Ref: Response to request for review of “Xiaogushan Hydropower Project in People’s Republic of China” (0378)

In response to the request for review of “Xiaogushan Hydropower Project in People’s Republic of China” (0378), we bring to your kind attention the following clarifications and responses.

Figure 1 Historic annual average water flow for Heihe River⁵

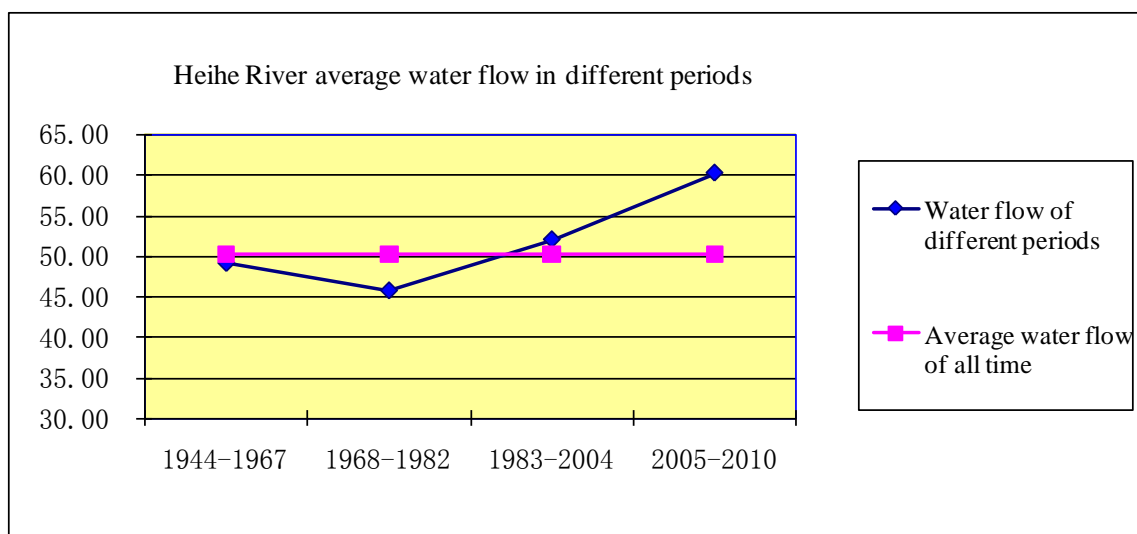
b) The period from 2005 to 2010 falls in a wet period in term of water flow in Heihe River. It was the first wet period since the start of the historic water record in 1944 and thus was not predictable at the time of project design when the Heihe River had been historically at its normal or dry periods in the previous 57 years (1944-2000).

During the period of 57 years (1944-2000), the Heihe River was statistically at its normal and dry periods in term of its water flow. The average annual runoff from 1944 to 2000 is $1.58 \times 10^9 \text{ m}^3$ and the annual water flow is $50.2 \text{ m}^3/\text{s}$. And the average annual water flow during the period of year 2005-2010 is $60.1 \text{ m}^3/\text{s}$ and exceeds the 57-year average value by 19.7%.

According to the recorded hydrological data the annual average water flow of the Heihe River increased significantly during the period of year 2005 and year 2010 compared to the average water flow during past 57 years. Most of the period prior to 2005 either be considered as normal (1944-1967, 1983-2004) or dry (1968-1982)⁴ when compared with the historical average water availability. But the period from between 2005 and 2010 falls in a wet period, the first wet period since the water survey bureau started monitoring water flow, where the average water flow rates are considerably higher than historical average due to high precipitation and heavy snow melting. Consequently, the electricity generation has been higher than the volume estimated in the project design during the concerned period. This pattern of increase in water flow and power generation was not at all anticipated at the time of project design.

Figure 2 Analysis of neighboring hydropower plants' Electricity Generation

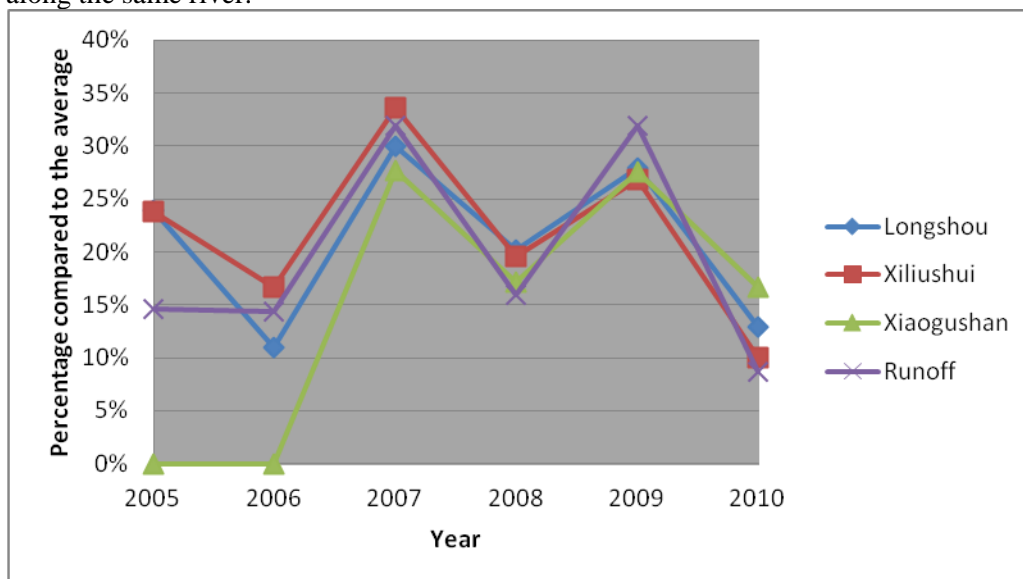
Xiaogushan Hydropower project is not an exceptional case in term of increase in power generation due to greater water flow. As a matter of fact, the power generation data (2005-2010) for the two other hydropower plants (Longshou and Xiliushui), which are located in the downstream of Heihe river shows a very consistent pattern with the generation data of the Xiaogushan power plant and the hydrological statistics of the Yingluo Gorge, which is illustrated

in Figure 2 below. The increased water flow has been consistently the case for all power plants along the same river.
